Access Compliance Report

Public Rights-of-Way

Intersection ID: N/A	Main Street: SPEER_BV	Cross Street: ARBOR_LOOP_DR	Location: SW
ADA ID: B93666F0EF8C	Ramp Type: Perp	Initial Pass/Fail: Fail	Overall Compliance: No
		Severity Score: 12.5

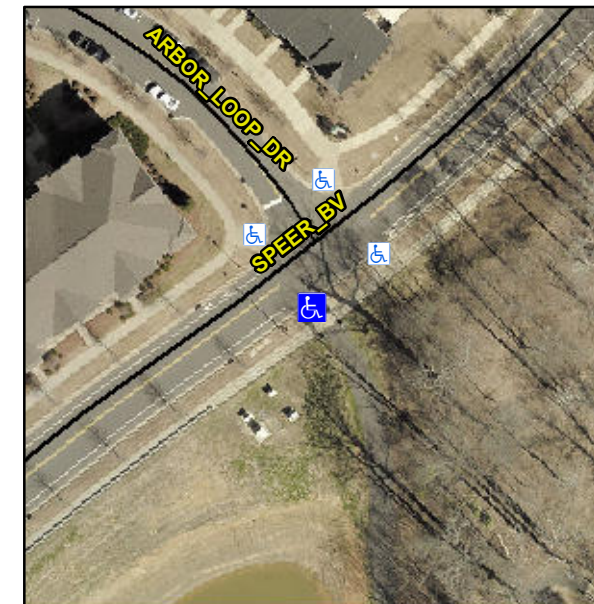
R304.2.2

Compliance	Description	Data	Compliance	Description	Data
N/A	Ramp Length (in)	94.0	No	Ramp Slope (%)	8.4
Yes	Ramp Width (in)	48.0	Yes	Ramp XSlope (%)	1.2
N/A	Flare Type LT	N/A	N/A	Flare Type RT	N/A
N/A	Flare Slope LT (%)	N/A	N/A	Flare Slope RT (%)	N/A
N/A	Flare Traversable LT?	N/A	N/A	Flare Traversable RT?	N/A
N/A	Landing Length (in)	N/A	N/A	DWS Provided?	N/A
N/A	Landing Width (in)	N/A	N/A	DWS Contrast?	N/A
N/A	Landing Slope (%)	N/A	N/A	DWS Length (in)	N/A
N/A	Landing X Slope (%)	N/A	N/A	DWS Full Width?	N/A
N/A	Landing Curb? (Y/N)	N/A	N/A	DWS Offset (in)	N/A
N/A	Shared Landing?	N/A			
N/A	Gutter Ponding?	N/A	N/A	Gutter Slope (%)	N/A
N/A	Gutter Lip Ht (in)	N/A	N/A	Gutter X Slope (%)	N/A
N/A	Painted X Walk1?	No	N/A	Painted X Walk2?	N/A
	X Walk 1 Direction	To N		X Walk 2 Direction	N/A
N/A	X Walk 1 Width (in)	N/A	N/A	X Walk 2 Width (in)	N/A
	X Walk 1 Slope (%)	5.1		X Walk 2 Slope (%)	N/A
	X Walk 1 X Slope (%)	0.4		X Walk 2 X Slope (%)	N/A

Remove & Replace Entire Ramp.
